Sea Link

Document 9.65: Statement of Common Ground Between National Grid Electricity Transmission and the National Trust.

Planning Inspectorate Reference: EN020026

Version: C
April 2026

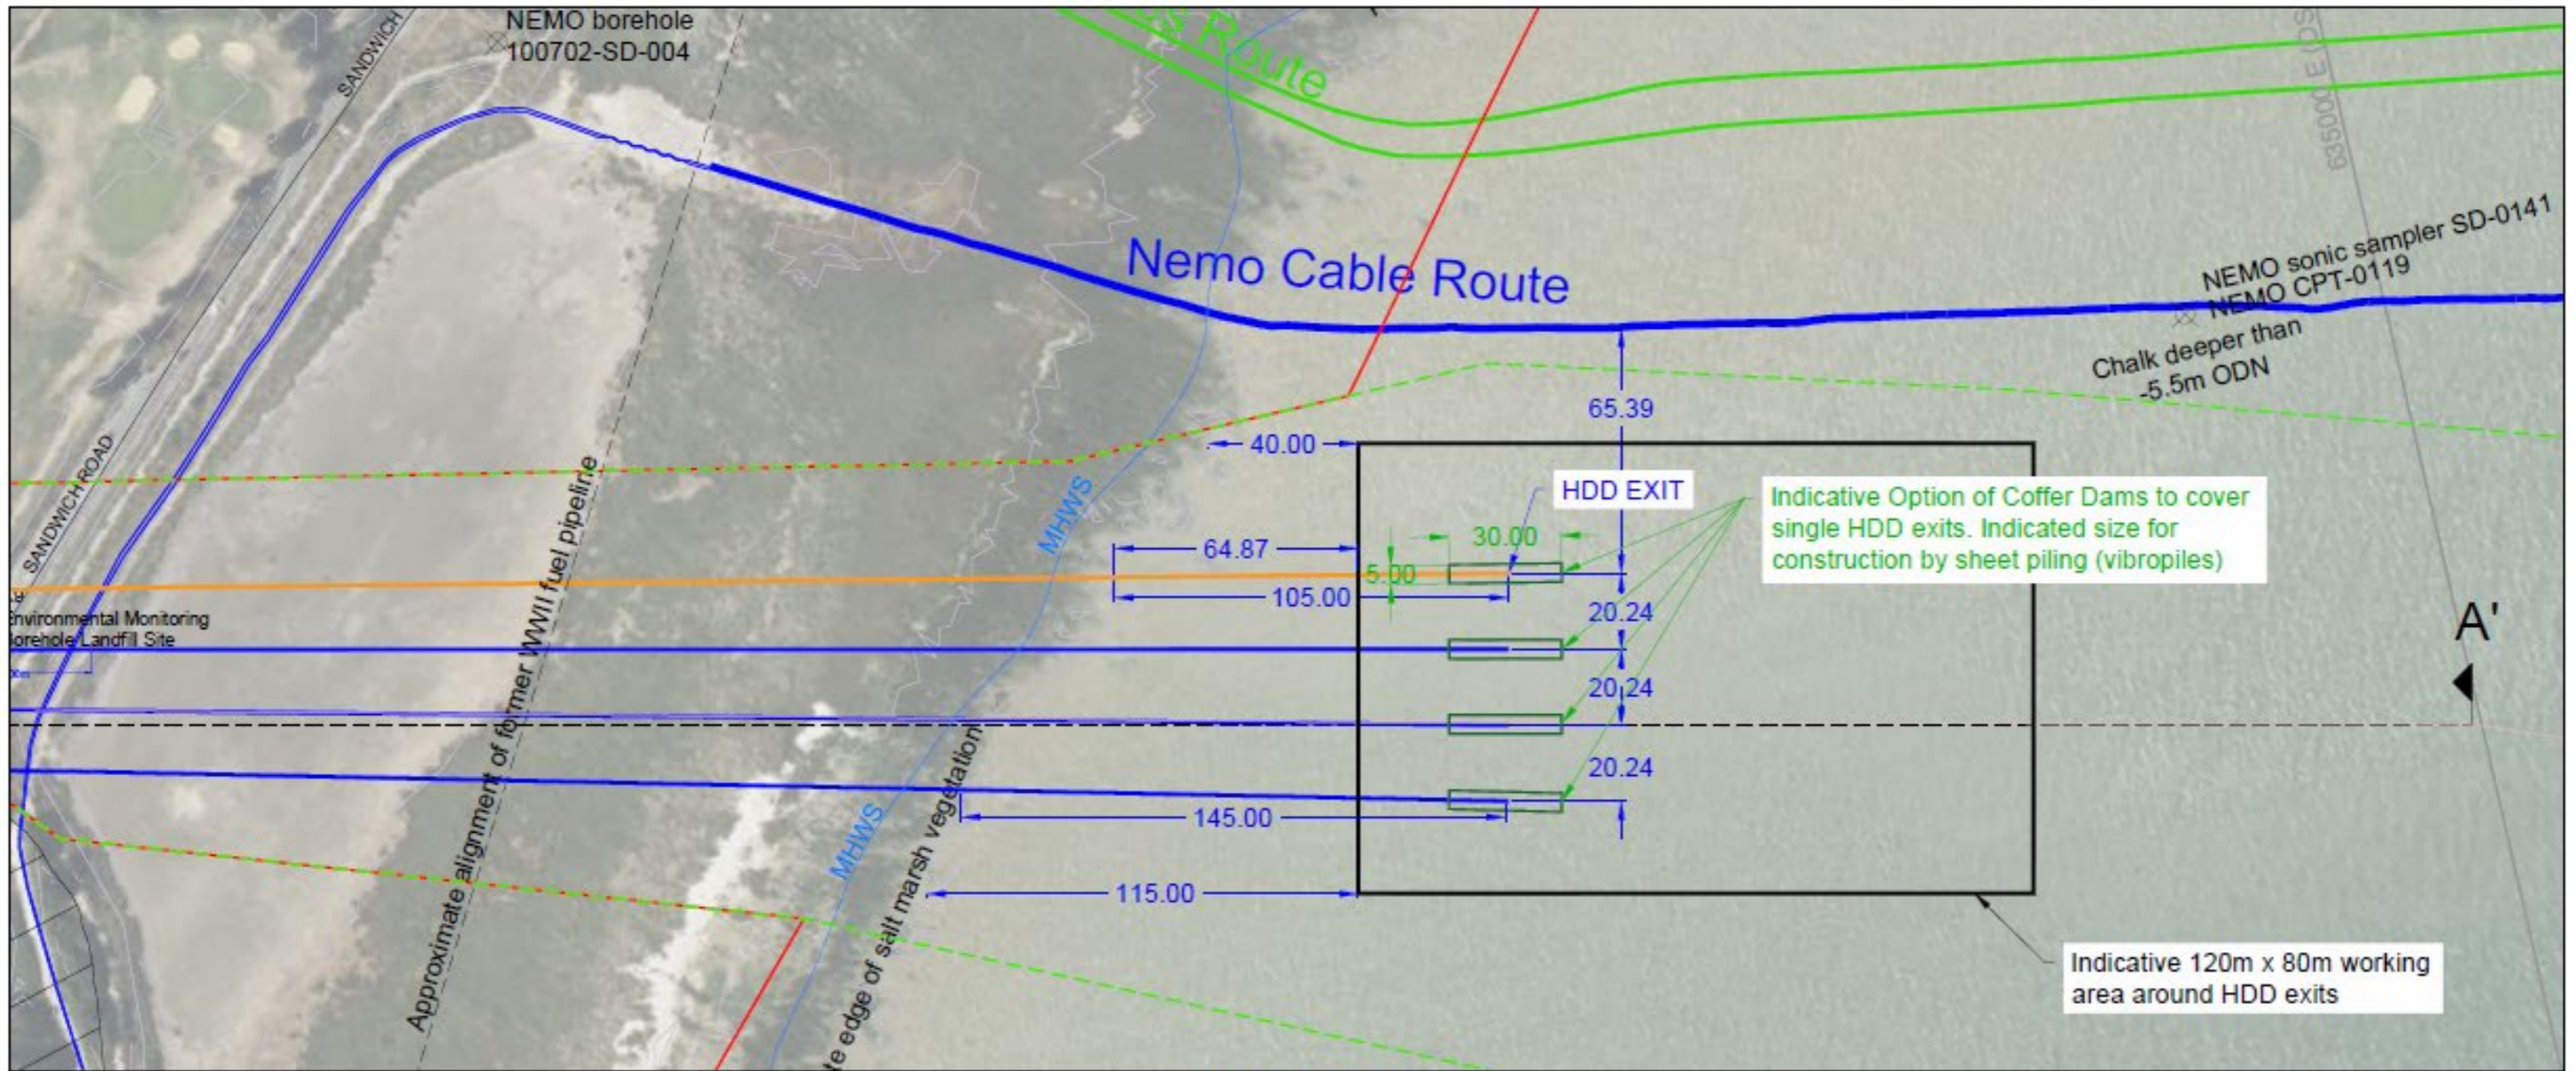
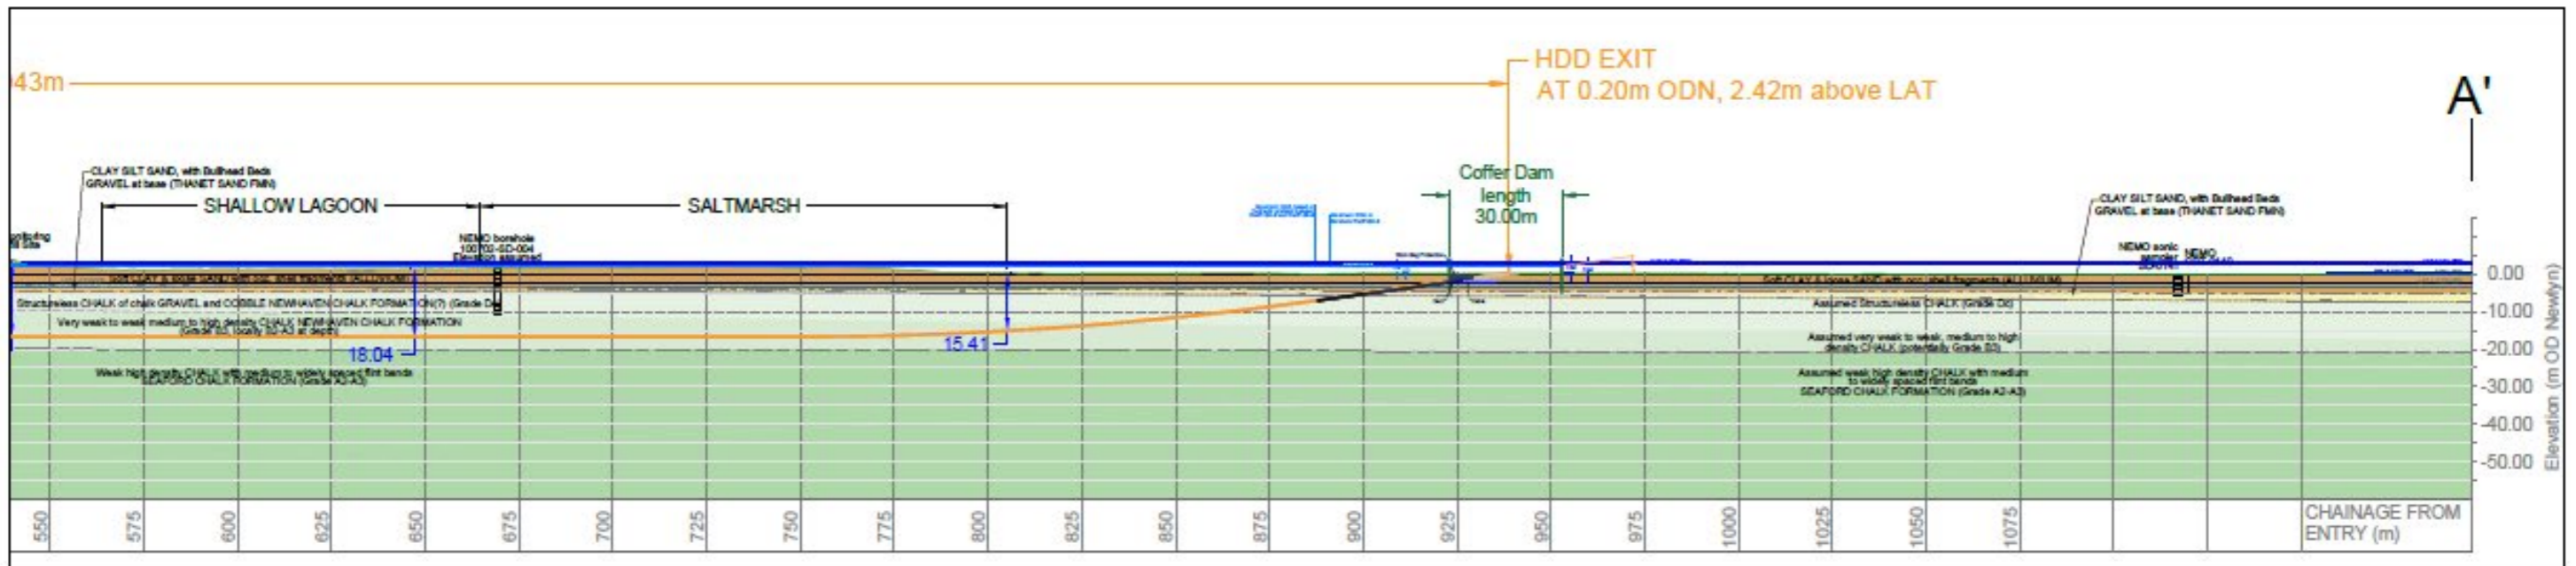
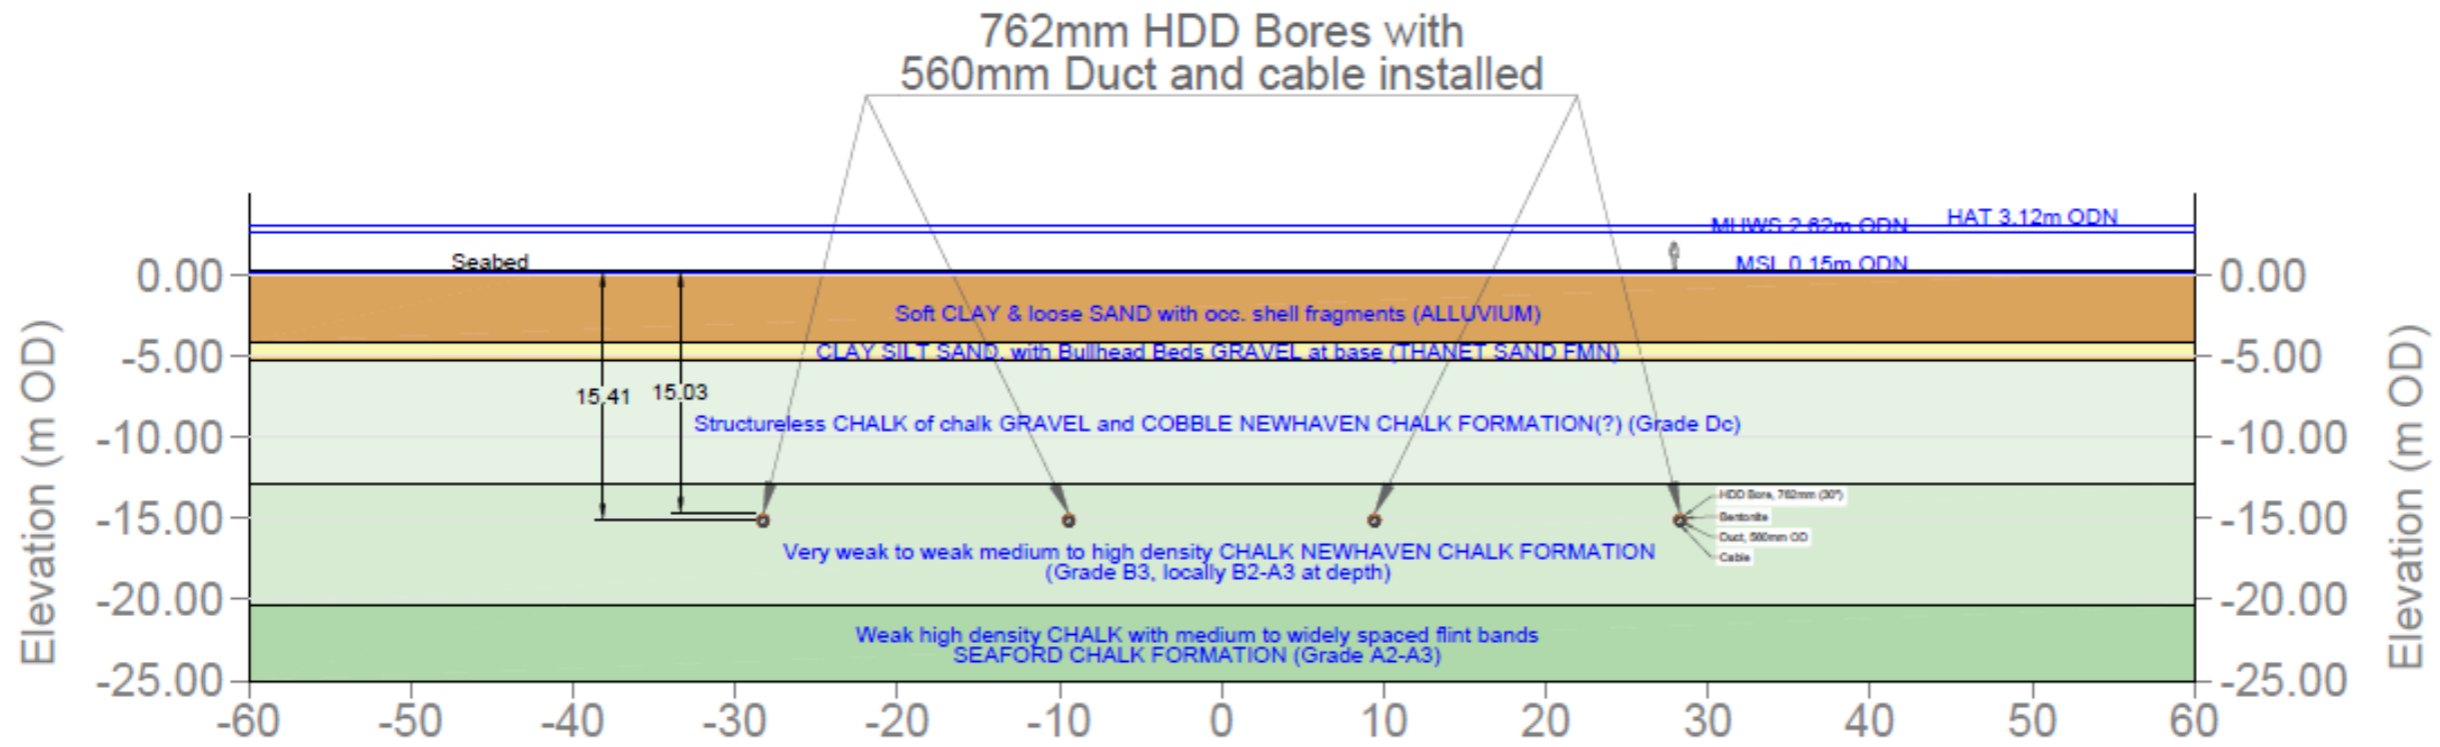
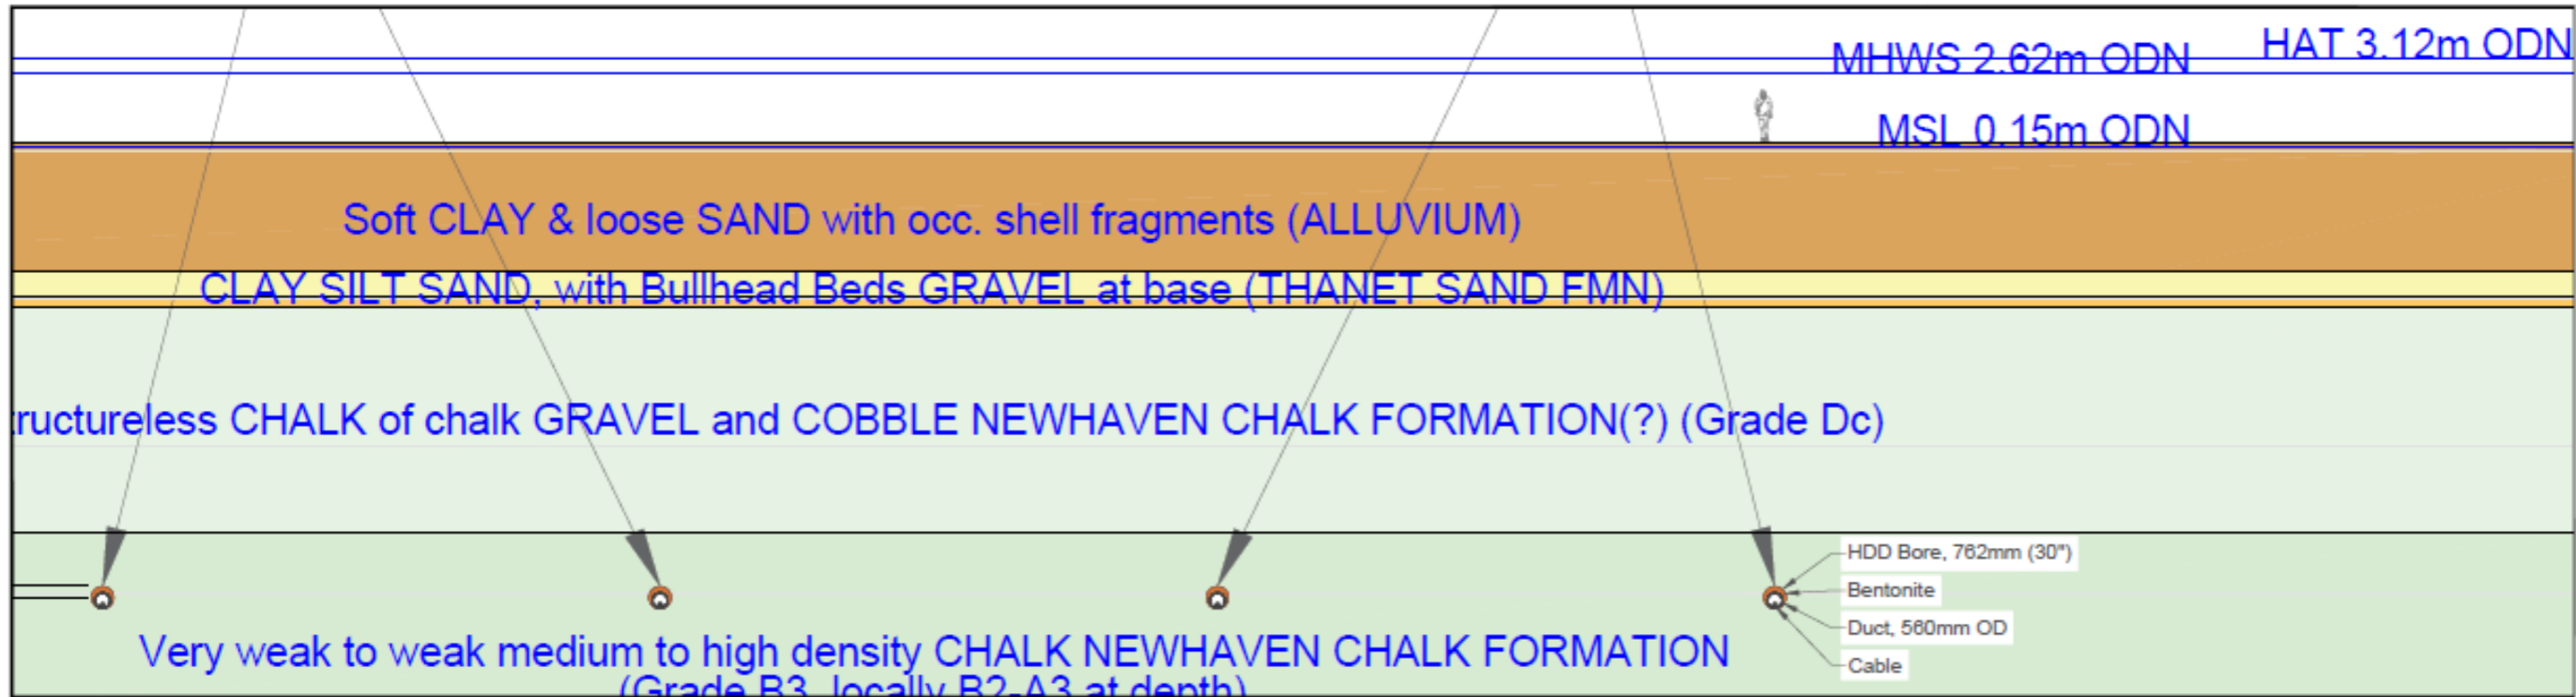
Ref	Relevant Application Documents	Description of Matter	Consultee's Current Position	The Applicant Current Position	Status
			<p>The Trust welcomes the Applicant's confirmation. The Trust seeks in addition that the Applicant completes an HDD Management Plan after first consulting with the Trust and other relevant stakeholders.</p>	<p>the pressure required to drill through the formation, to cause a surface frac out in the SSSI. Therefore, there is a very low risk of frac out.</p> <p>The Applicant can confirm that the HDD contractor will produce a detailed, drilling fluid management plan (B59 of the REAC) to be approved by the MMO in consultation with relevant stakeholders including Natural England and the National Trust, that includes drilling fluid breakout mitigation measures, where HDD is proposed. This is currently secured within the Deemed Marine Licence through Application Document 9.92 (A) Outline Cable Specification and Installation Plan [REP4-090] submitted at Deadline 4, Application Document 7.5.2 (B) Outline Offshore Construction Environmental Management Plan [REP4-223], and also within Application Document 9.84 (B) Register of Environmental Actions and Commitments [REP4-234] under B59.</p> <p>In addition to the above, a HDD Landfall Method Statement will be developed for Pegwell Bay following detailed design which is currently secured within the Deemed Marine Licence through Application Document 7.5.2 (A) Outline Offshore Construction Environmental Management Plan [APP-339]. The National Trust will be consulted on this document. This document [APP-339] was updated and re-submitted at Deadline 5 and now secures all mitigation relevant to the Offshore Scheme including both landfalls. Commitments to monitoring has been included in this document for both Suffolk and Kent landfalls.</p> <p>The Onshore CEMP (section 3.5), and REAC measure GG24 secures the production of an Incident Response Plan. Contact details for the ECoW overseeing works on land owned by the National Trust will be provided to National Trust. Should any environmental issues arise during construction on National Trust's land that are noted by the ECoW, National Trust will be notified and a meeting offered to discuss any actions required, in line with the procedures specified within the Incident Response Plan described in GG24.</p> <p>A list of relevant securing mechanisms for the Proposed Project is provided in Appendix A. In addition to this, a cross sectional image of the HDD exits in the intertidal at Pegwell Bay are presented in Appendix B.</p>
